Darling Harbour Live – The Haymarket Stage 2 State Significant Development Application (SSDA 5) – Hyder Consulting response to City of Sydney recommendations, Transport for NSW letter and the Department of Planning and Infrastructure comments.

DARLING HARBOUR LIVE

DESIGNERS RESPONSE TO
PRELIMINARY ROAD SAFETY
AUDIT

DRAWING
SKCPD095

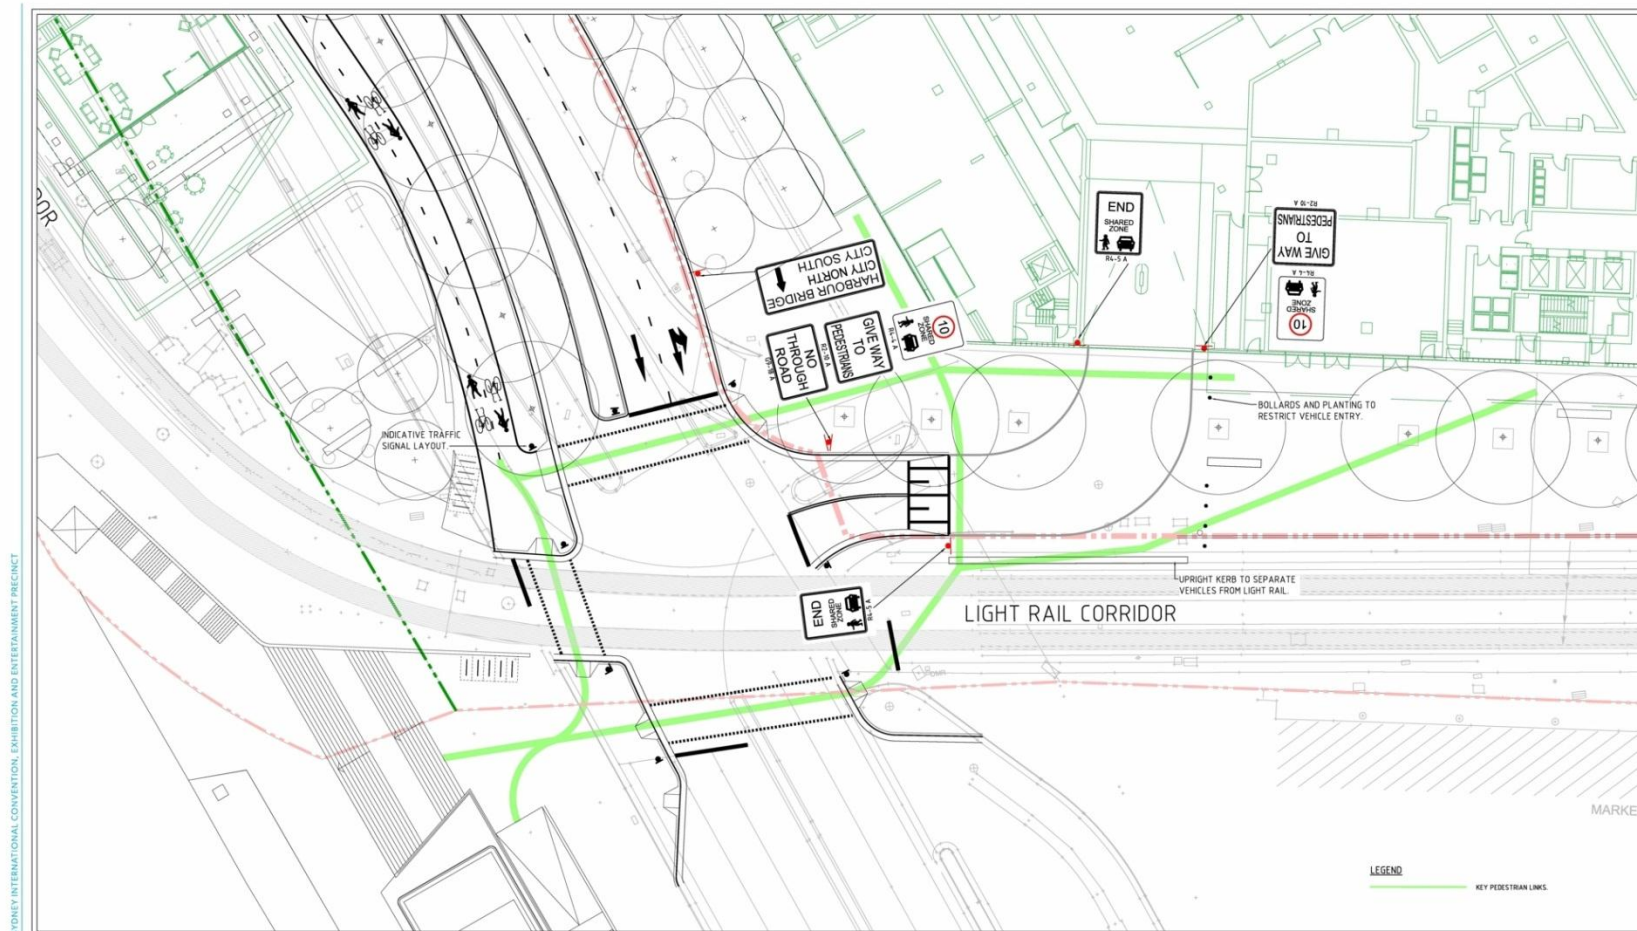
Department of Planning and Infrastructure	Hyder Response
Traffic and Transportation 3. Clarification that the Hay Street driveway and crossover are appropriately designed and would encourage a safe pedestrian environment is required.	Refer to the previous detailed response for an explanation supporting the preferred resolution for Hay Street. Hyder confirms the proposed design solution for Hay Street has been resolved with safety as a key factor.

FIGURE 1

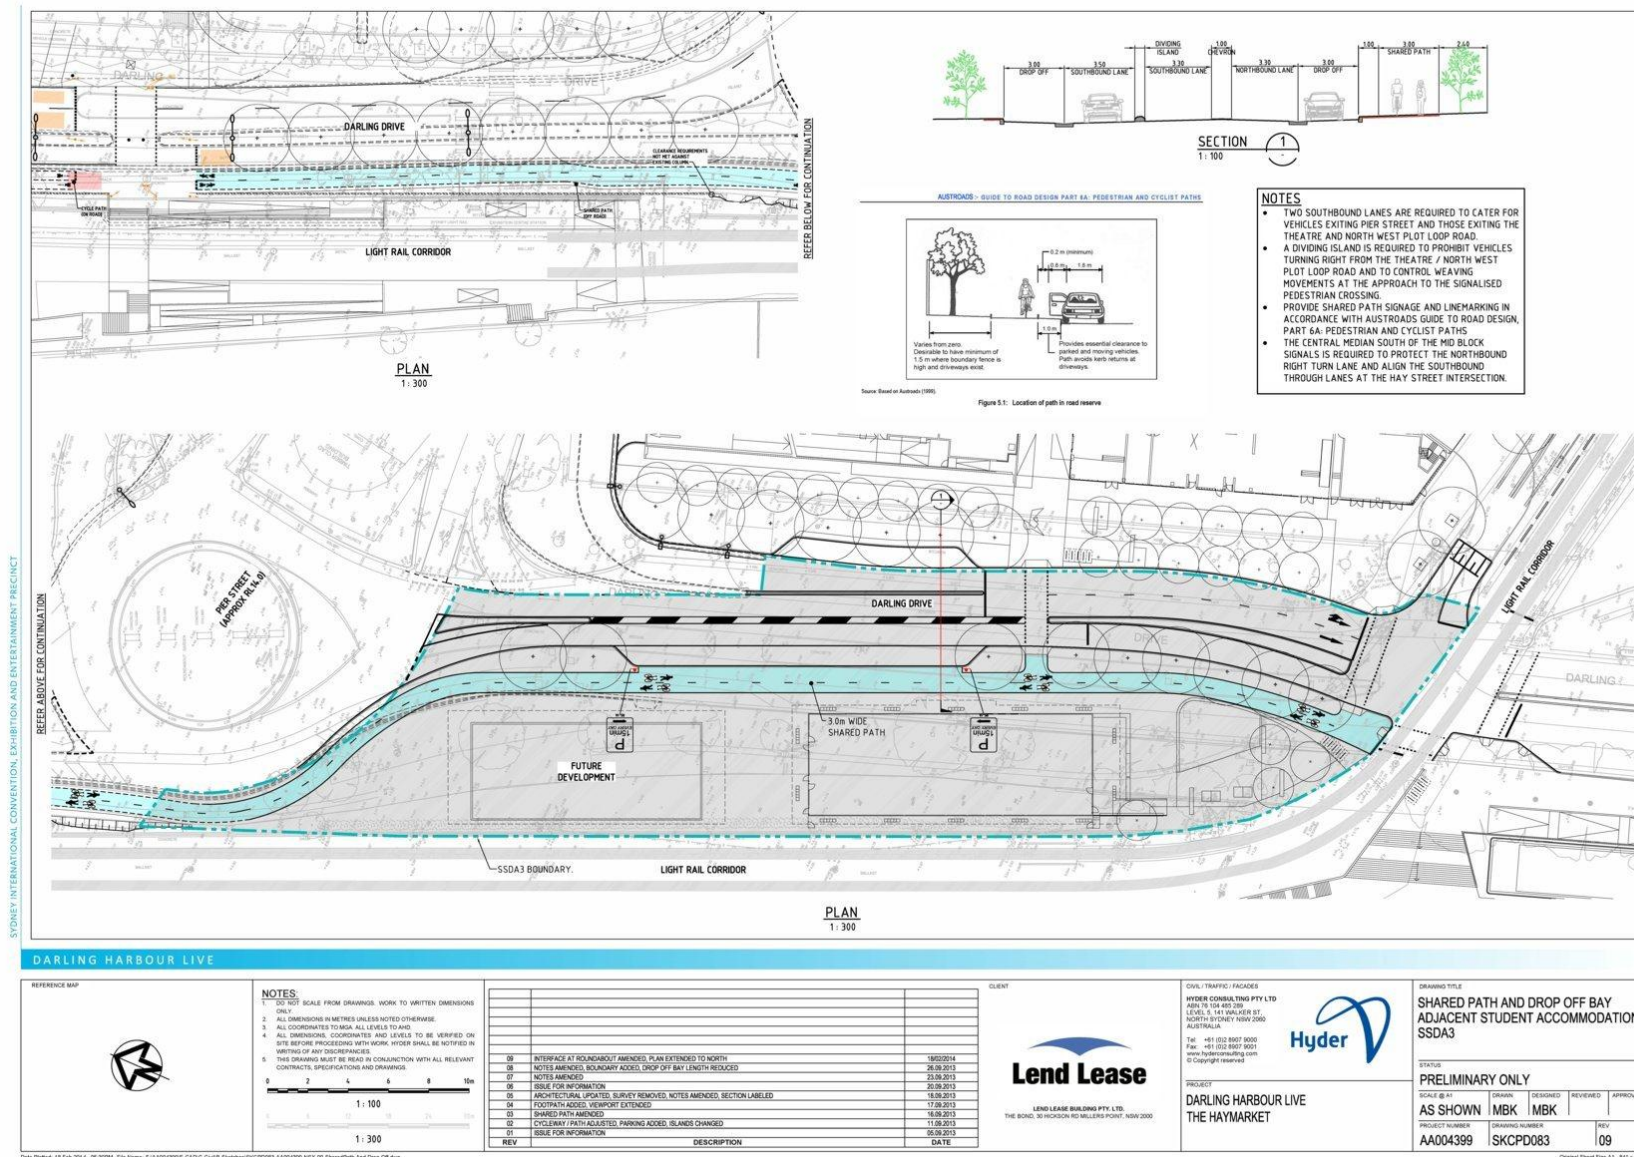
Department of Planning and Infrastructure	Hyder Response
6. Clarification is required of the proposed pedestrian connections west to Ultimo and east to the CBD.	West to Ultimo, within the Southern Precinct, the key proposed pedestrian connections are illustrated in Figure 1 and include: - A connection between The Goods Line and Darling Drive via the Macarthur Street walkway connection. This access is provided via the lift and stair integrated into the existing elevated Macarthur Street walkway, which then utilises The Goods Line to connect to Darling Drive via a ramp and stair (the subject of a separate application known as The Goods Line); - The pedestrian crossing across Darling Drive will be maintained at the signalised Hay St/ Darling Drive intersection; and - The new signalised pedestrian crossing facility on Darling Drive under SSDA3 providing a pedestrian linkage from the west of Darling Drive through to the Boulevard via Hay Street and Dicksons Lane. Pedestrian connections to the CBD on the east will be maintained via the existing Hay Street and Golbourn Street pedestrian linkages. Further north of SSDA5, pedestrian connections to the CBD are provided via the Boulevard to Tumbalong Park then onwards to the east via the existing pedestrian walkways to/from the CBD (Refer to attached Figures 1 and 2)

Figure1: Revised Theatre layout design

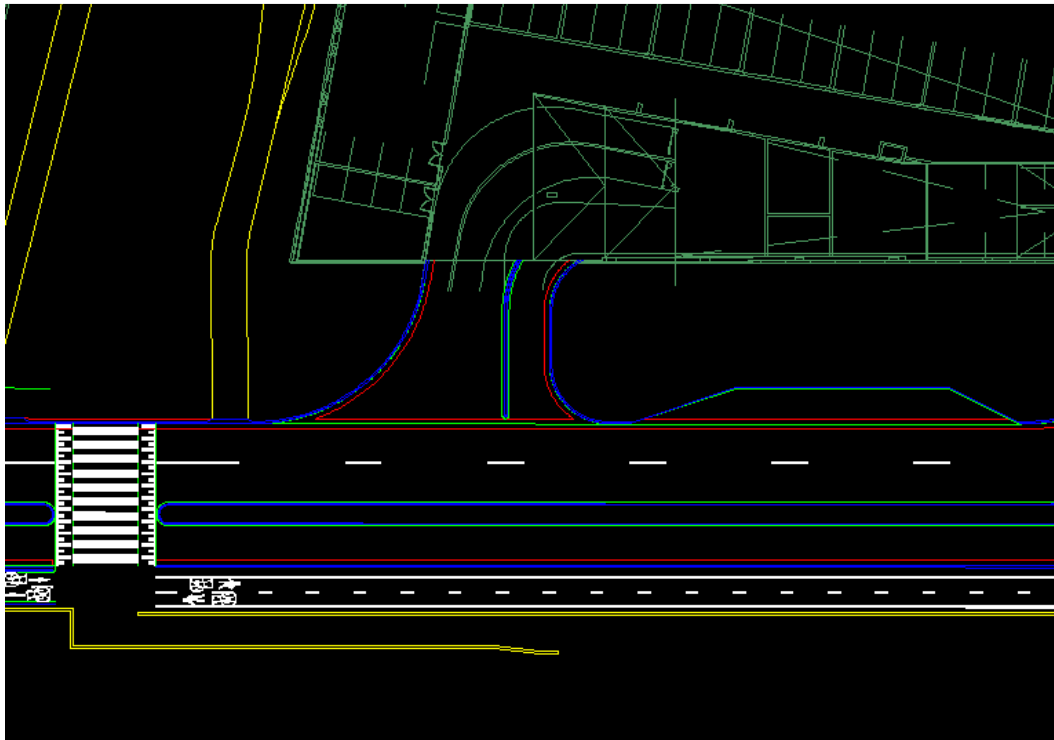
Since the road safety audit was undertaken, there has been a design change in the vicinity of the proposed Theatre car park access and egress. Previously, access for vehicles entering and exiting the Theatre car park, was provided on Exhibition Place. There was a proposed taxi holing zone to the west of the Theatre building, linked to Darling Drive. The pedestrian crossing linking Tumbalong Place and the light rail stop was proposed as either a zebra crossing or a staggered crossing.

Following the change to the Theatre building, access and egress will now be provided to the Theatre car park from Darling Drive. The taxi holing area has been replaced by an indented bus stop and the proposed pedestrian crossing is now proposed as a signalised crossing. Please see Figure 1 below:

We have now reviewed the left-in-left-out access/egress associated with the Theatre car park. We regard this to be a similar set of circumstances as the previously proposed taxi rank as the taxi rank is essentially a left-in-left-out arrangement. As per the audit report we had no issue with the taxi rank. As such, we also have no issue with the current proposal to have a left-in-left-out arrangement for the Theatre car park.
